DEVELOPMENT APPLICATION ASSESSMENT REPORT

Application Number:	DA2022/1715
----------------------------	-------------

Responsible Officer:	Gareth David
Land to be developed (Address):	Lot 56 DP 7794, 60 Hudson Parade CLAREVILLE NSW 2107
Proposed Development:	Alterations and additions to a dwelling house including a swimming pool
Zoning:	C4 Environmental Living
Development Permissible:	Yes
Existing Use Rights:	No
Consent Authority:	Northern Beaches Council
Delegation Level:	DDP
Land and Environment Court Action:	No
Owner:	Oliver Hartley Nicola Jane Hartley
Applicant:	Brook Lane Property Group Pty Ltd

D1.8 Front building line

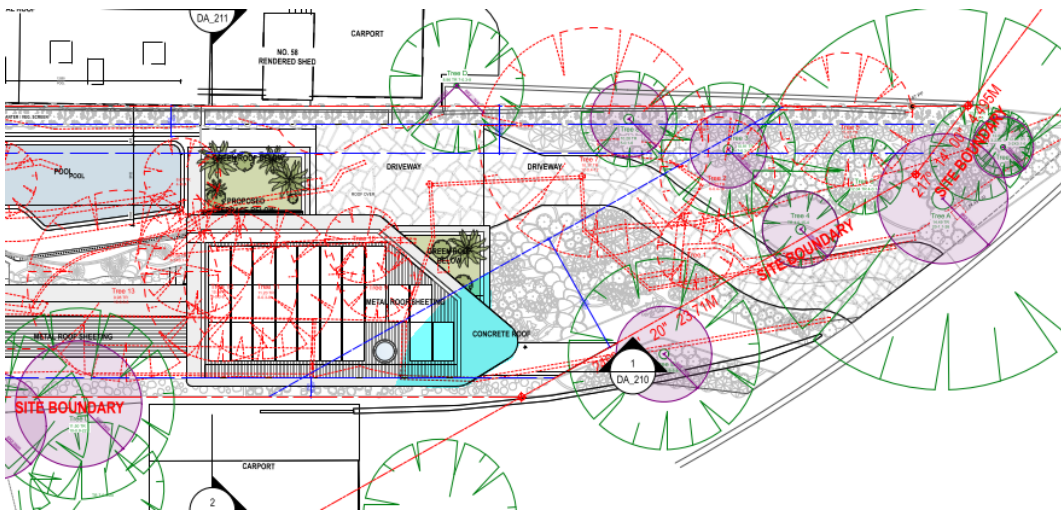
The area which protrudes in front of the 6.5m requirement is highlighted in blue in figure 1 below:

It should be noted that the site is an irregular shaped block with a obtuse angled frontage as demonstrated in the figure above.
